PEDRO FALCON CONTRACTORS, INC.

Request for Change Order

Project: Glynn Archer Gym

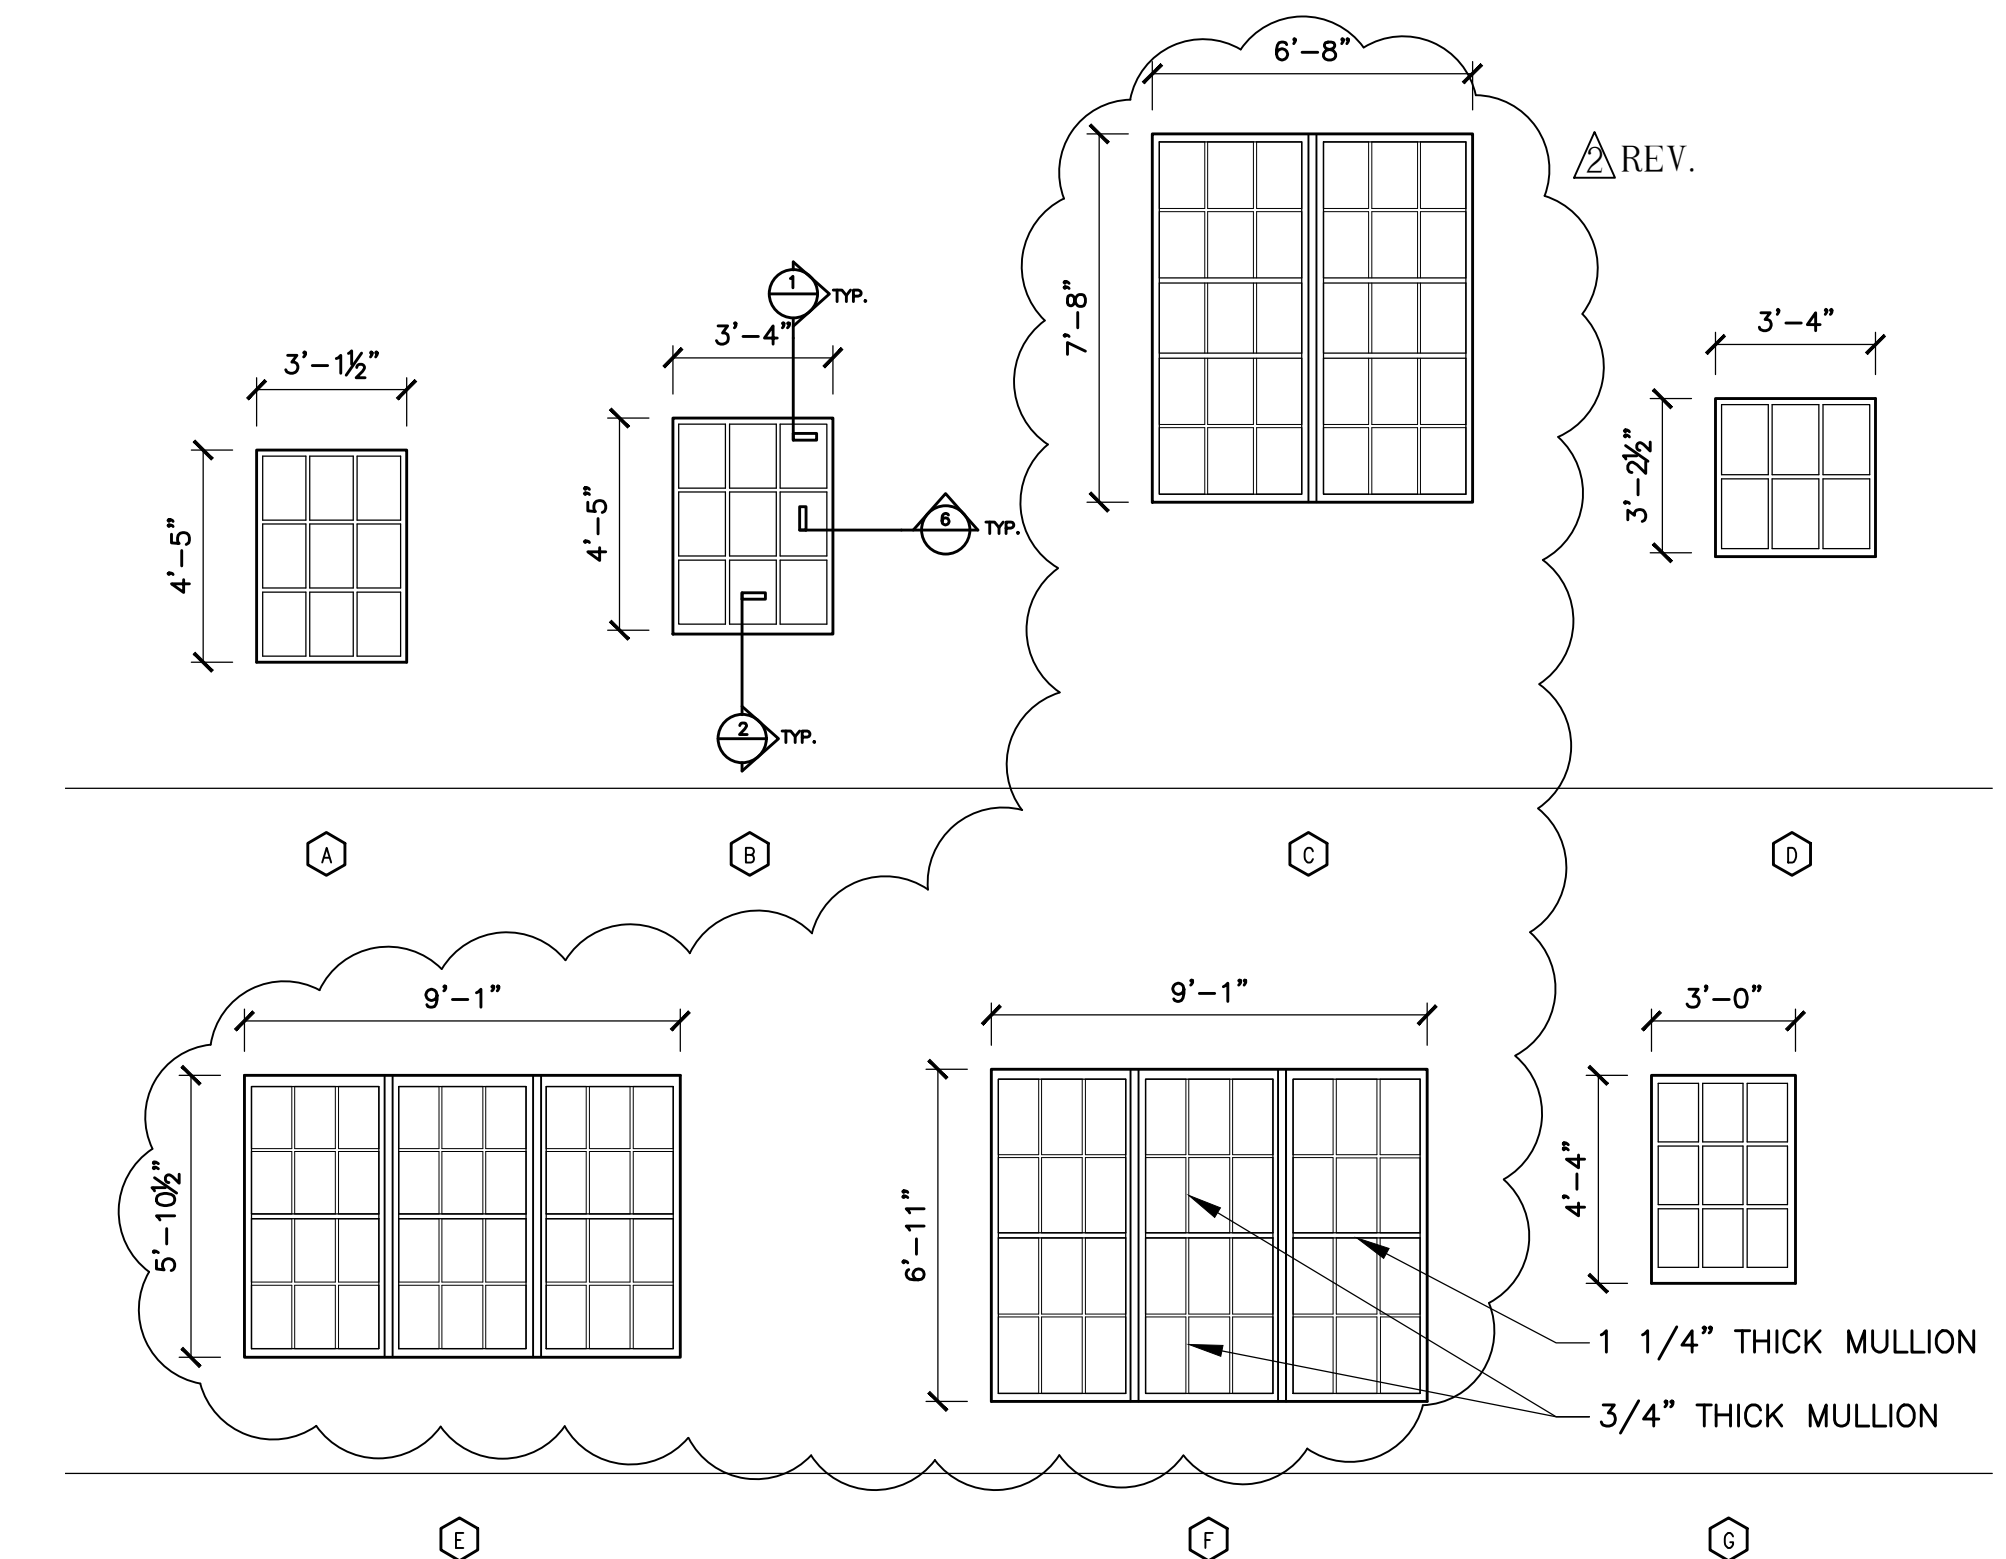
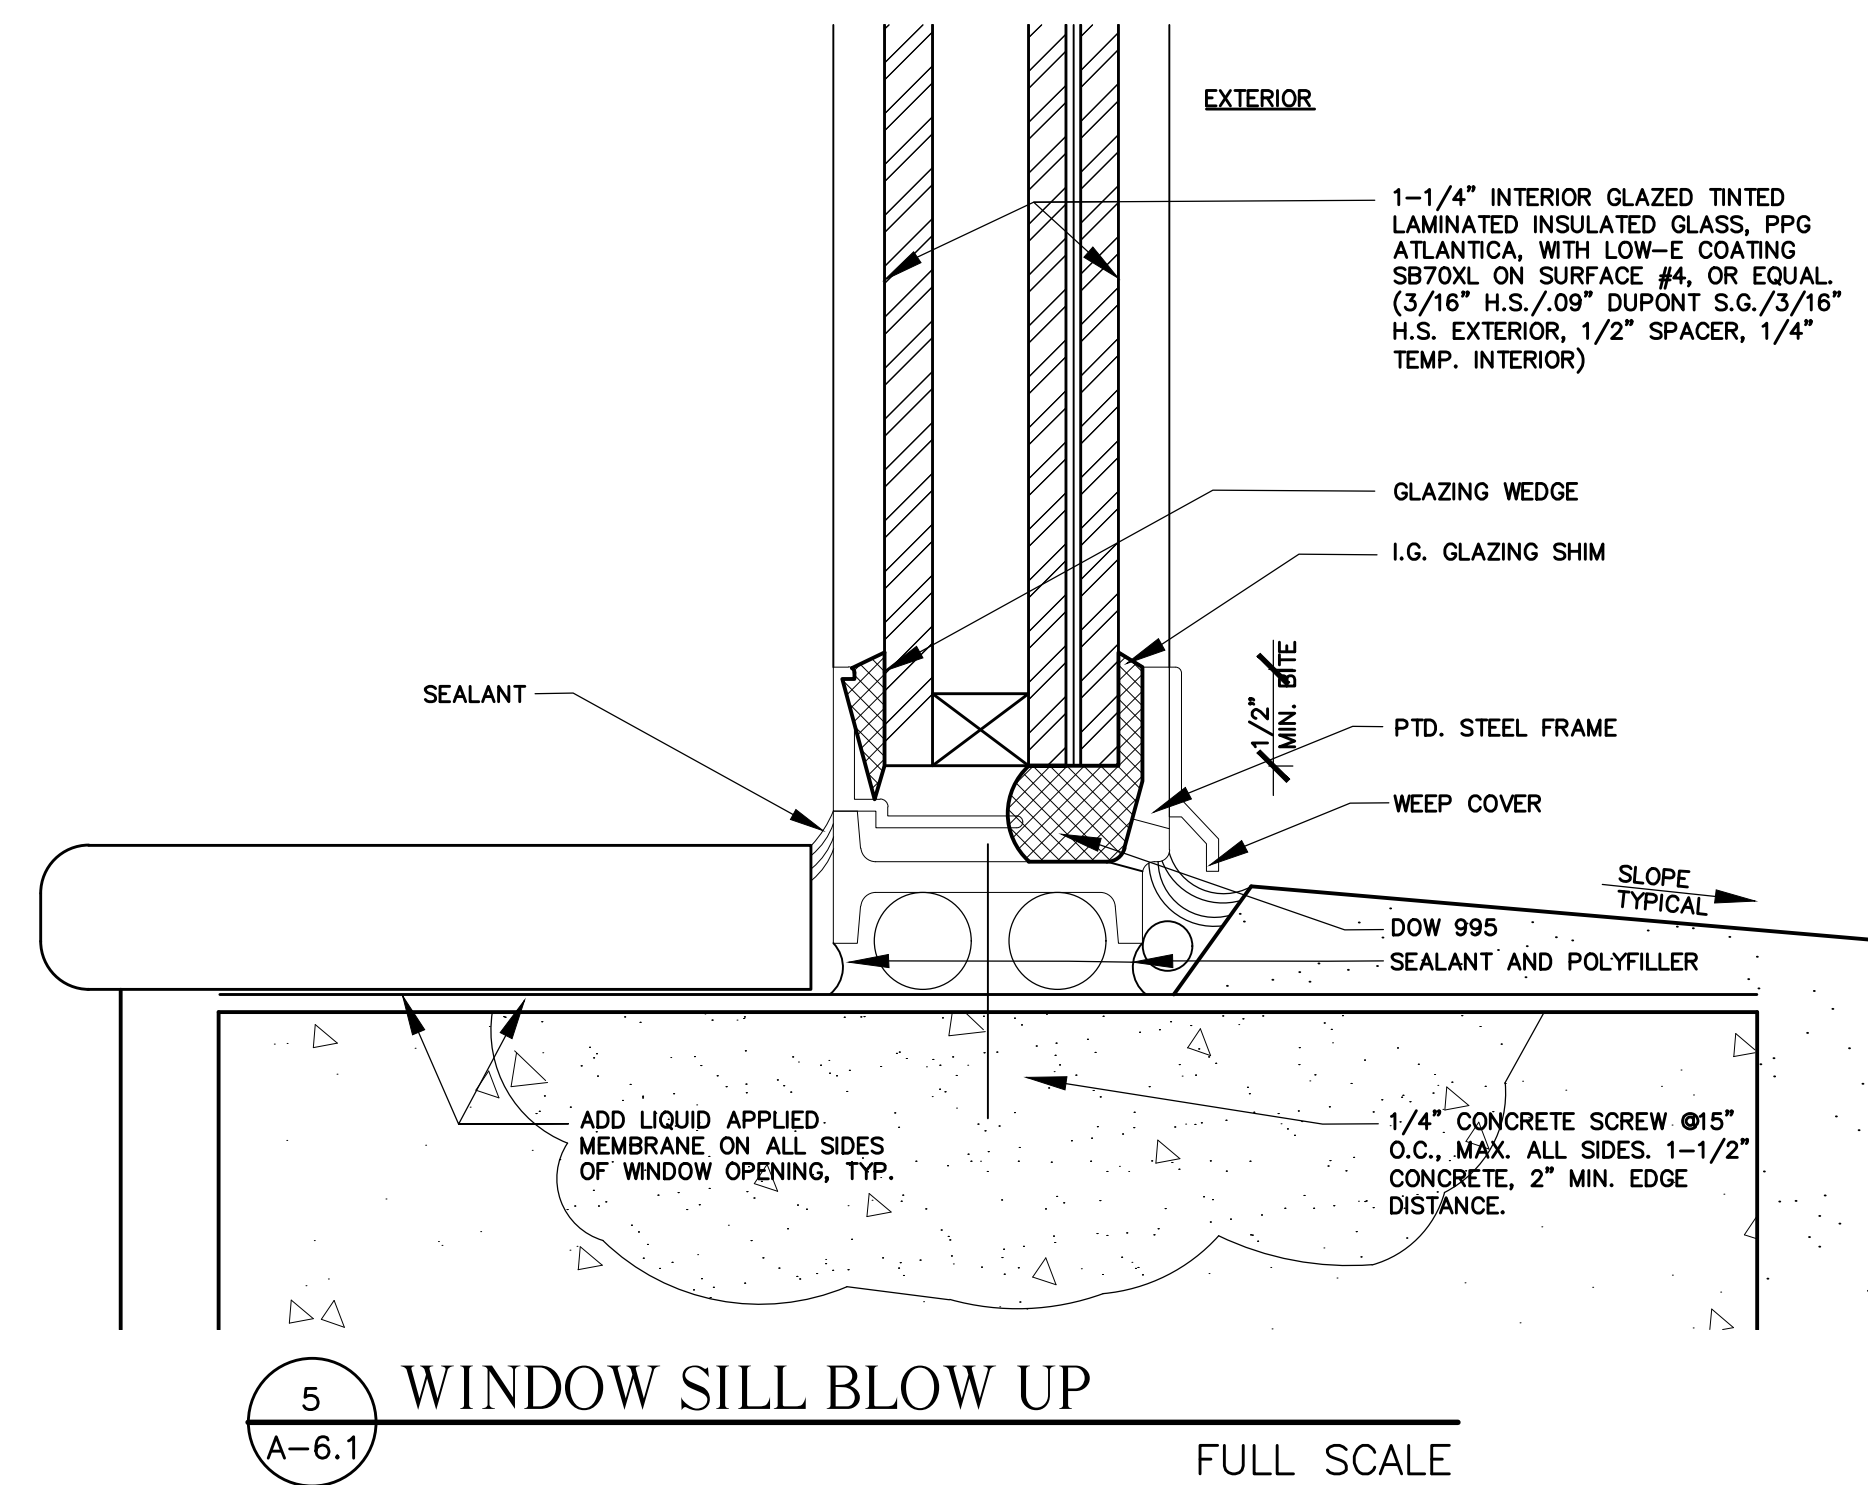
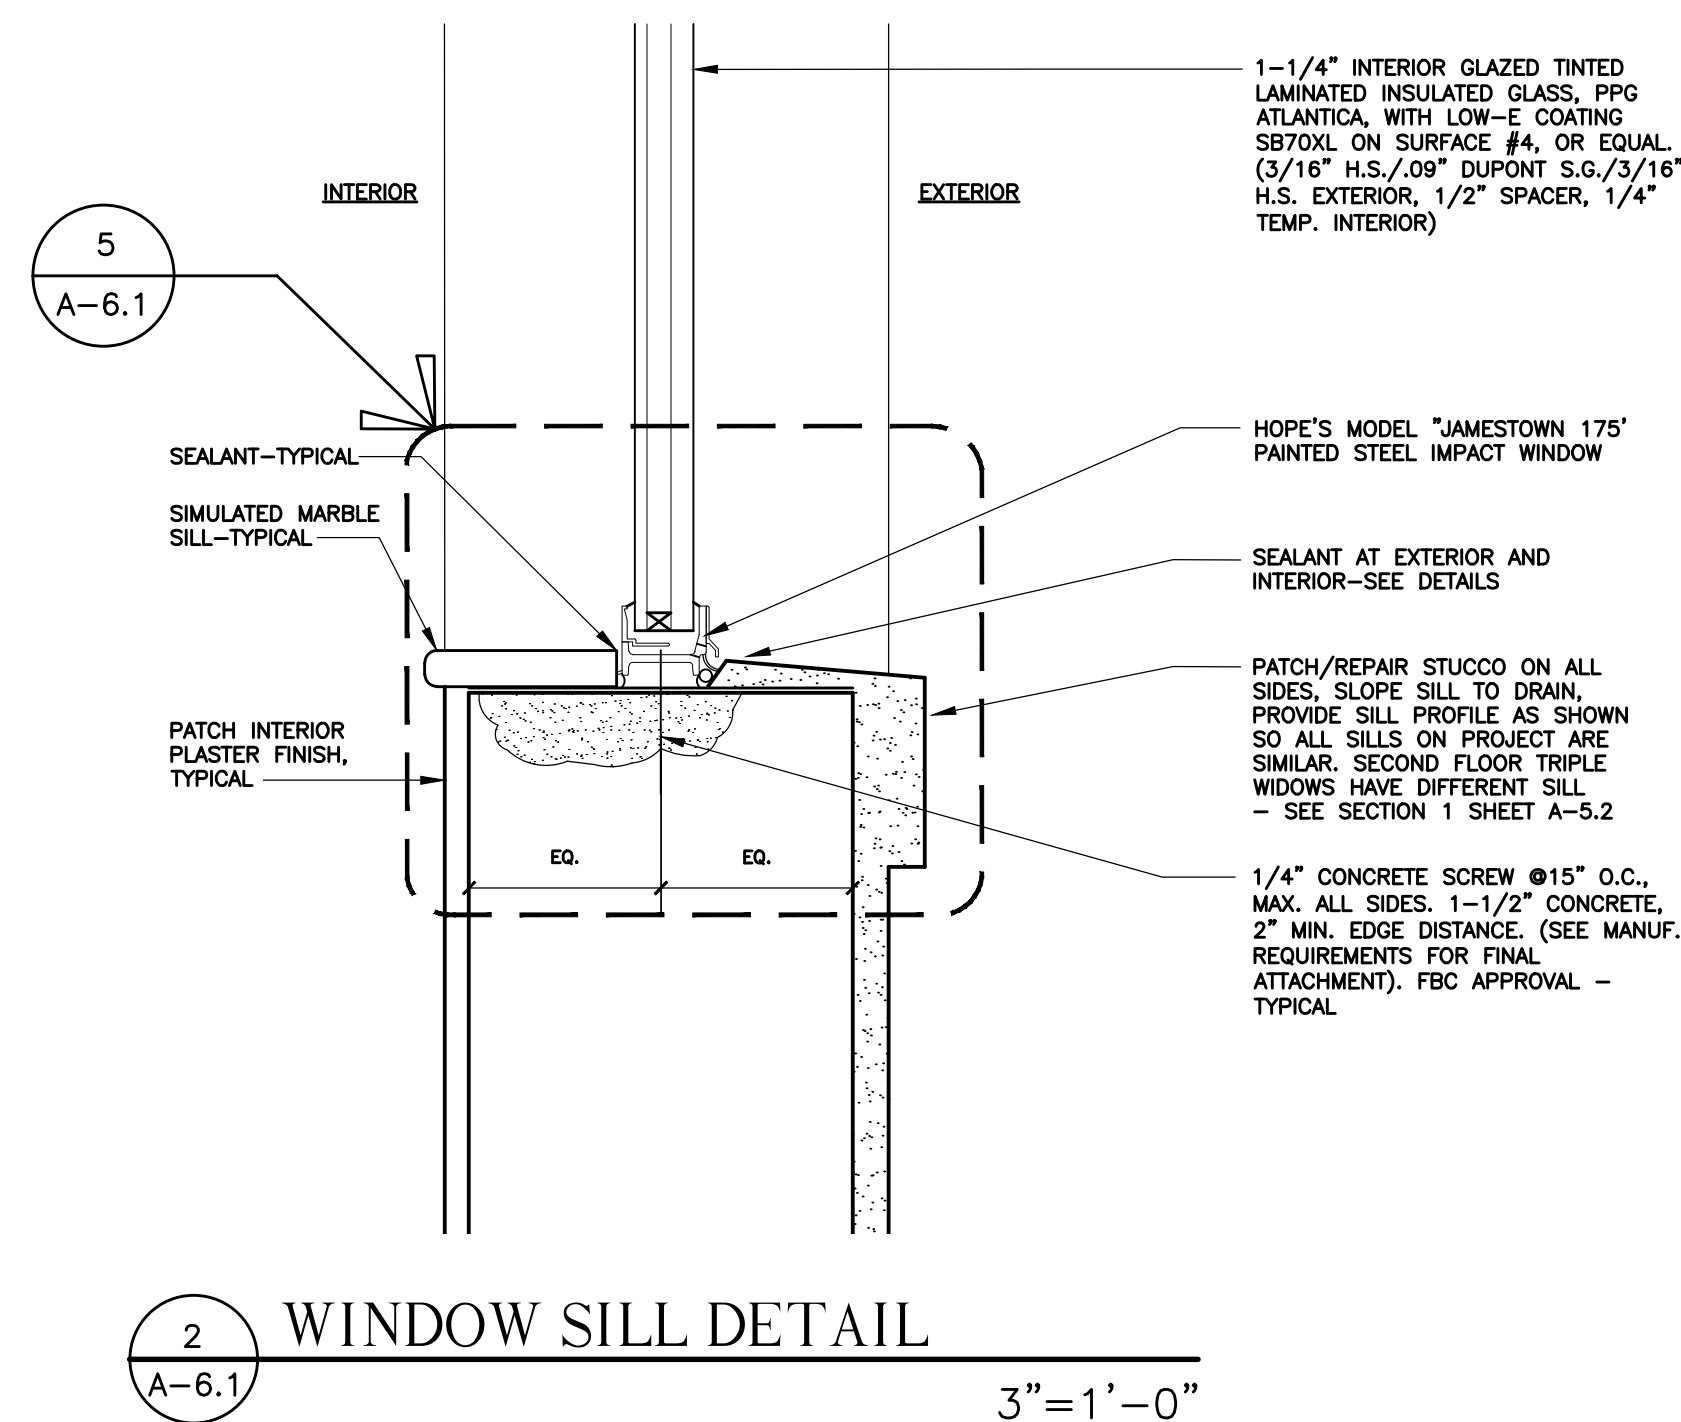
Description: Response to RFI #13 which included a revised drawing for the exterior windows. (see attached revised A-6.1 Drawings enclosed)

Furnish and install a custom simulated divided muntins as shown on the revised architectural drawing sheet A-6.1

To furnish custom simulated divided muntins as requested per architectural drawing sheet A6.1
..... **ADD \$4,651.00**
